PRODUCT CHANGE NOTIFICATION NO: PC-20200730

PCN DATE: Jul 30th, 2020

2X6 ICM Product

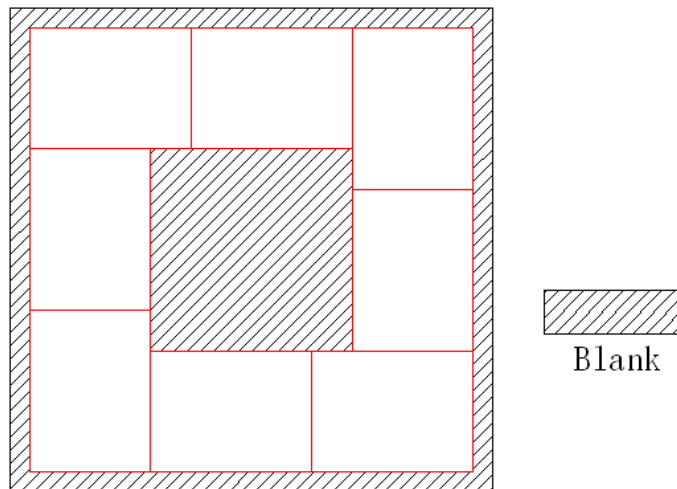
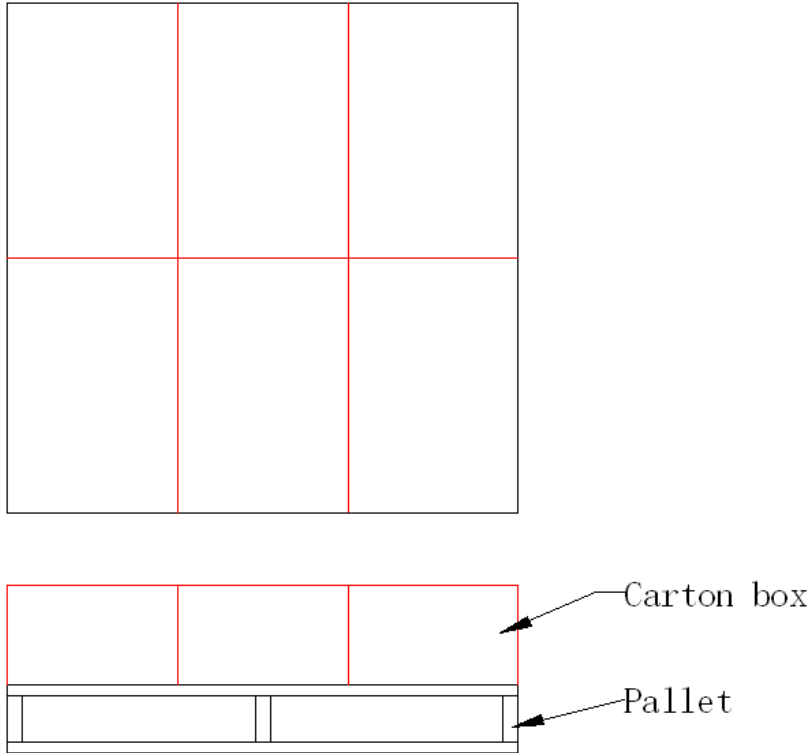
Change carton box to optimize palletization.

The customer requests the label must face toward outside, this leads to a low pallet volume efficiency.

Carton box is changed, SPQ/PPQ & MOQ are changed. (Package tray is not changed.)

New package passed drop test.

1. Palletization is like below picture

Pallet volume efficiency: 67%

2. Pack 20 pcs per carton box for part A

3. Pack 30 pcs per carton box for part B

1. Palletization is like below picture

Pallet volume efficiency: 100%

2. Pack 60 pcs per new carton box for both part A and B, the MOQ will be changed accordingly.
